**From:** John Smethurst | Clement Acoustics <john@clementacoustics.co.uk>  
**Sent:** 01 February 2018 13:47  
**To:** Diver, John  
**Subject:** Re: Fwd: RE: 47 Mill Lane, NW6 1NB AoD (Condition 2) - 2017/6197/P

**Re: 47 Mill Lane, NW6 1NB**

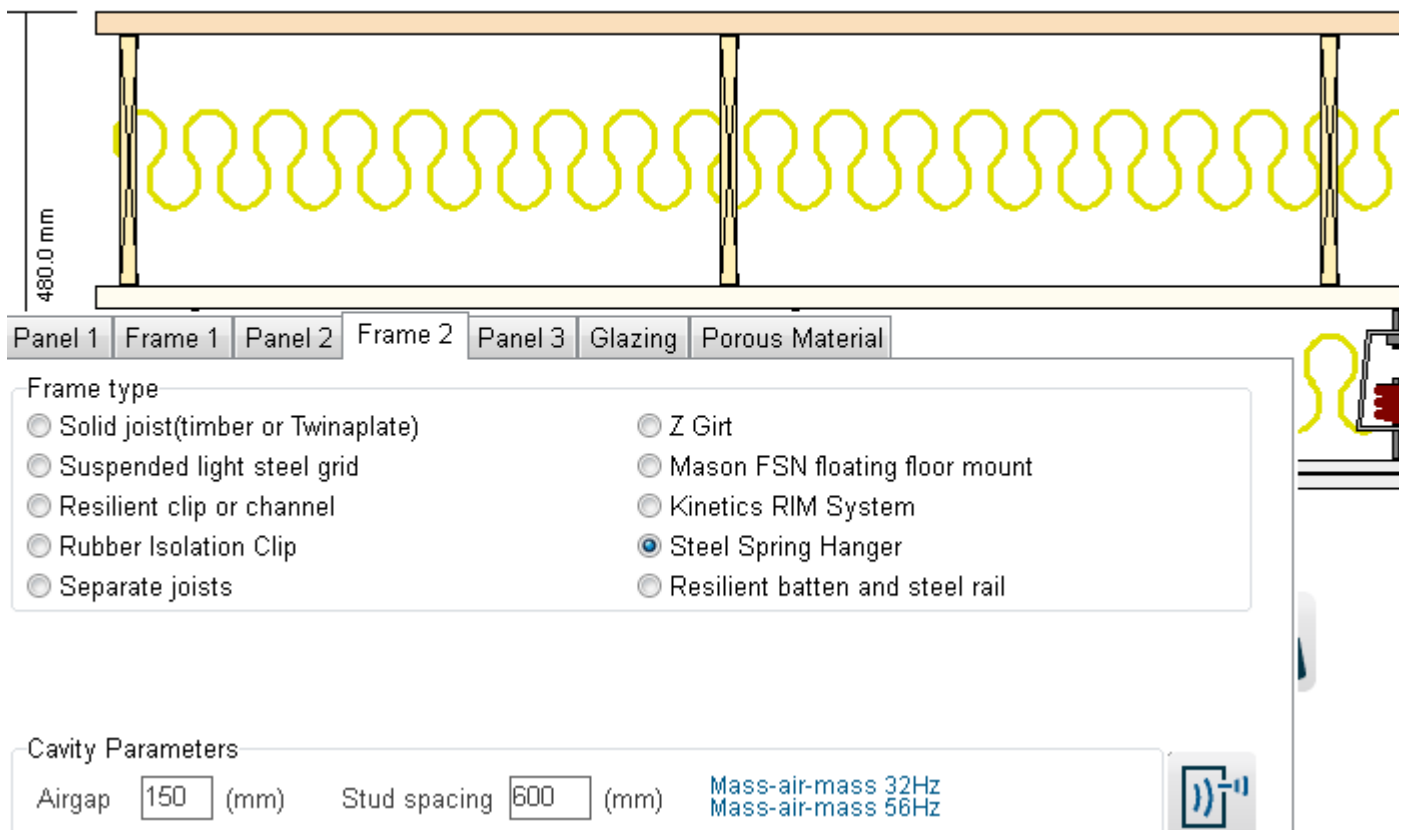
The screen shot below shows the assumed ceiling giving a very poor sound insulation

After reviewing the submitted Acoustic Report with members of the Council's Environmental Health (Noise) team, further information was requested as to how the consultants (Clement Acoustics) has reached their predicted sound insulation performance figure for the ceiling (60dB) at paragraph 5.1. Considering that access to the 1<sup>st</sup> floor flat was not possible, confirmation of the calculations to reach this figure are therefore required to confirm the overall acceptability.

As indicated in the screen shot above, the predicted performance is  $R_w + C_{tr}$  69 dB. For a timber construction a correction of 5 to 8 dB is generally assumed for on-site flanking. Therefore, assuming a worst case flanking correction of 8 dB, the floor should be capable of providing an on-site performance of approximately  $D_nT_w + C_{tr}$  61 dB.
